UNITED STATES PATENT AND TRADEMARK OFFICE

APPLICATION NO.	FILING DATE	FIRST NAMED INVENTOR	ATTORNEY DOCKET NO.	CONFIRMATION NO.
10/737,330	12/17/2003	Michael Anthony Zerillo		7560

Office Action Summary	Application No. 10/737,330	Applicant(s) ZERILLO, MICHAEL ANTHONY	
	Examiner Noah C. Hawk	Art Unit 3637

DETAILED ACTION

Small, Figure 2

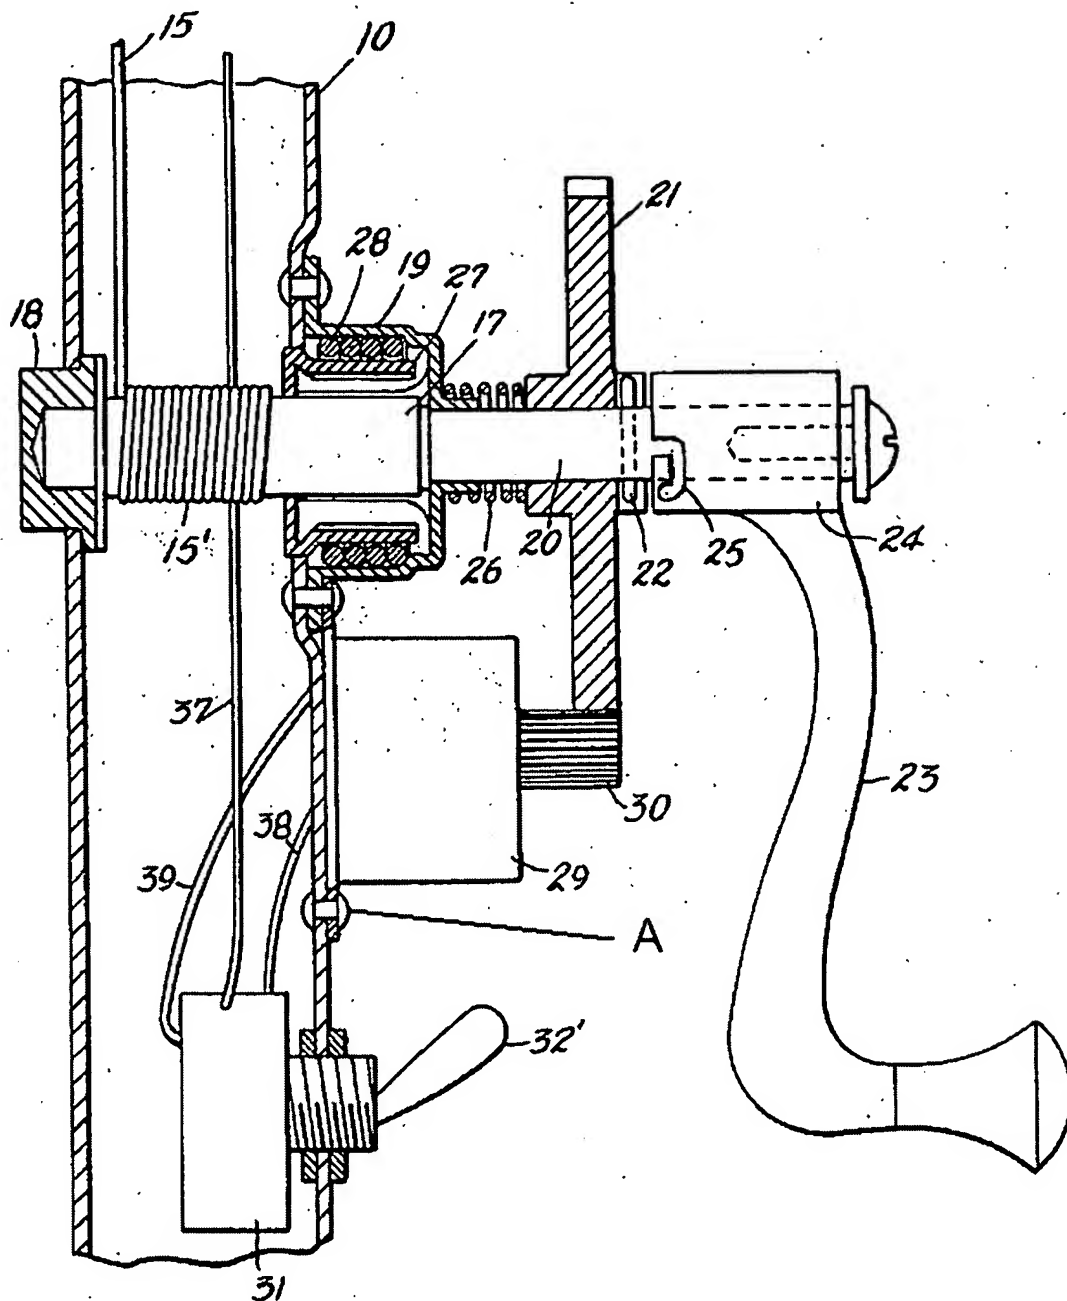
6. Claim 1 is rejected under 35 U.S.C. 103(a) as being unpatentable over Lai in US Patent 6182917 in view of Small in US Patent 2960094. Lai discloses an electric opening and closing device for umbrellas, the device comprising a reversible electric motor (21), a reel drivingly engaged with the motor (24) a housing means for the motor and the reel (12), a length of cable (33) affixable at one end to the reel, a means to provide electricity (See Lai, Column 2, lines 14-15), a switch (10) having two means (See Lai, Column 4, lines 12-15) to connect the electricity to the motor, a remote control receiver (11) having two means (See Lai, Column 4, lines 12-15) to connect the electricity to the motor, and a remote control transmitter (See Lai, Column 1, lines 26-28) having means to control the remote control receiver. Lai is silent on which direction the motor turns as related to the switch or remote control receiver, however it would be obvious for the motor to turn in one direction such as clockwise when a controlling means such as a switch or remote receiver is thrown one way and another direction such as counterclockwise when the controlling means is thrown another way and to further be stopped or at rest when the controlling means is in a rest position. Lai

does not disclose that the opposite end of the cable is affixable to the patio umbrella opening and closing means, nor does he disclose a means to affix the housing to the patio umbrella at a location to thereby establish control of the patio umbrella opening and closing means. Small discloses a motor device for an umbrella, the device having a cable (15) affixed at one end to a reel (17), the opposite end of the cable being affixable (See Small, Column 1, lines 50-54) to the patio umbrella opening and closing means (13). Small also discloses a means (A) to affix the housing to the patio umbrella at a location to thereby establish control of the patio umbrella opening and closing means. It would have been obvious to one of ordinary skill in the art at the time of invention to modify the device of Lai by using a cable attached at an opposite end to the patio umbrella opening and closing means and to use a means to attach the housing a location to thereby establish control of the patio umbrella opening and closing means as taught by Small in order to ensure that the motor is in control of the operation of the umbrella and that it is firmly attached at a convenient position to the umbrella.
